Report to General Manager

SUBJECT: Council Response to the Proposed Milsons Point Ferry Wharf Upgrade

This report has been prepared in response to the proposed upgrade of the Milsons Point Ferry wharf. NSW Roads and Maritime Services advised Council on 21 October, 2016 of the proposed upgrade of the Milsons Point ferry wharf. The upgraded wharf will include a second ferry berth to the east of the current berth. This will significantly reduce the queueing for ferries waiting to embark and disembark passengers at the current single berth. The proposal will also result in improved disabled access facilities to the ferry wharf.

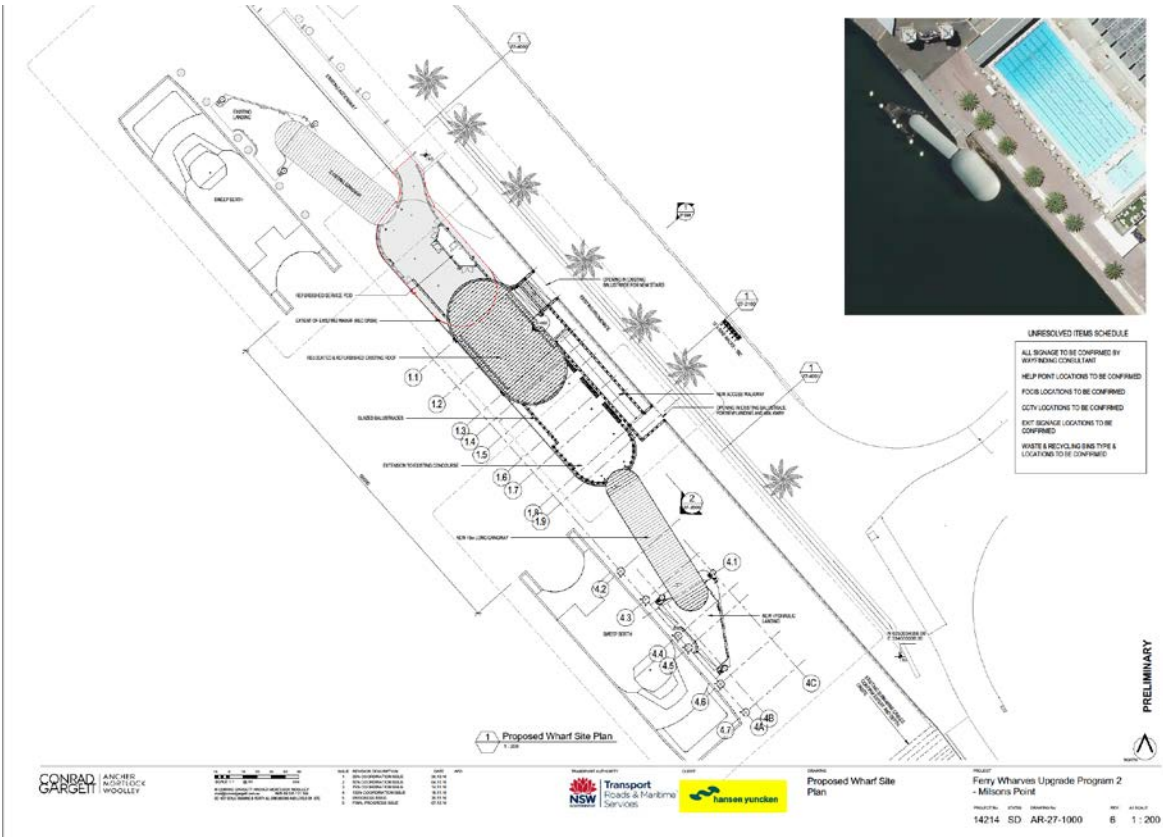
The proposal is to create a second berth extending from a central covered wharf. The design and materials will be in accordance with the standard ferry wharf palette and will be similar to the current style.

The red oval in the diagram indicates the current location of the covered area.

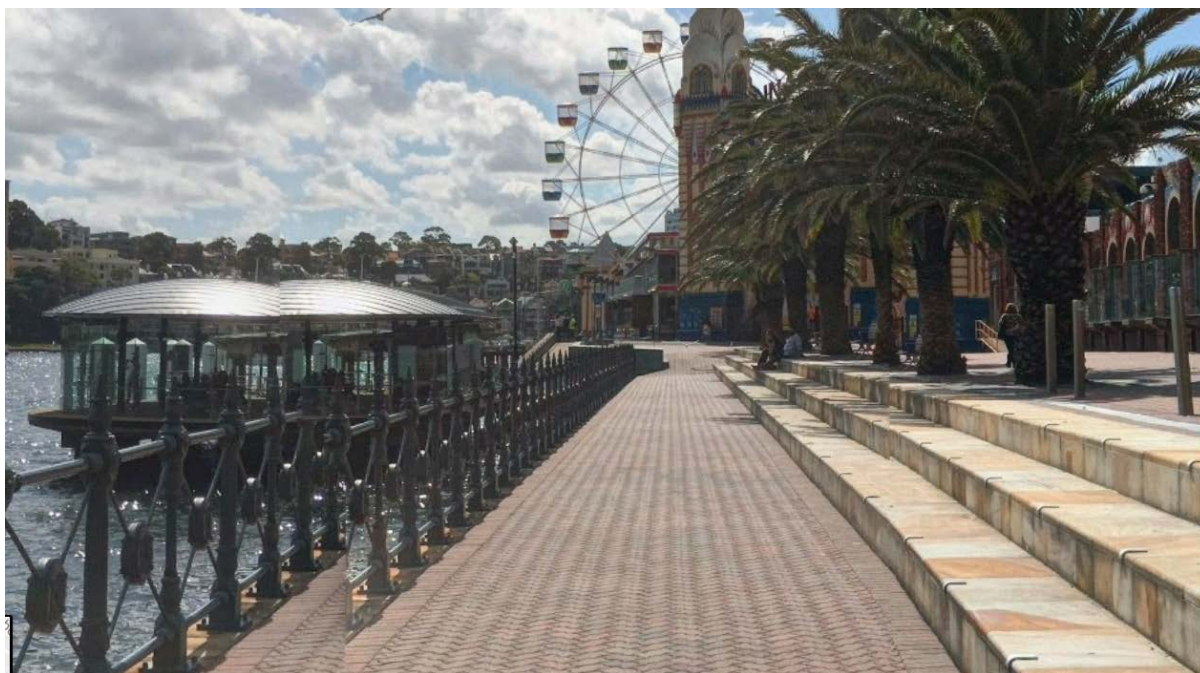
The proposal involves removing the current centrally located all-weather waiting area and relocation it as shown in the diagrams above. The site has been inspected to assess any potential view loss. It is noted that the roof and walls will partially impede the views of the Harbour from the Olympic Pool however the pool is set higher than the wharf by approximately 1.5m. As a result, pool users will have uninterrupted views of the City, the bridge and circular quay. These views are highly valued and measures should be taken to prevent further obstruction.

The photo below shows the view from the Olympic Pool windows.

The photo above shows the current ferry wharf with the view of Sydney and the Harbour Bridge.

The new ferry wharf will be located to the left (to the approximate location of the bench shown in the photo).

The photo below (from Google Streetview) shows the relative heights of the pool windows and the ferry wharf. The relative heights will remain unchanged.

A full consideration of view loss indicates that there will be some loss of views of the water but the iconic views (City, Harbour Bridge, Circular Quay and Opera House) from Milsons Point remain significantly intact. It is noted that the walls of the wharf are full height clear glass permitting views from the foreshore promenade. In the circumstances it is considered that any impact on views from various vantage points is reasonable.
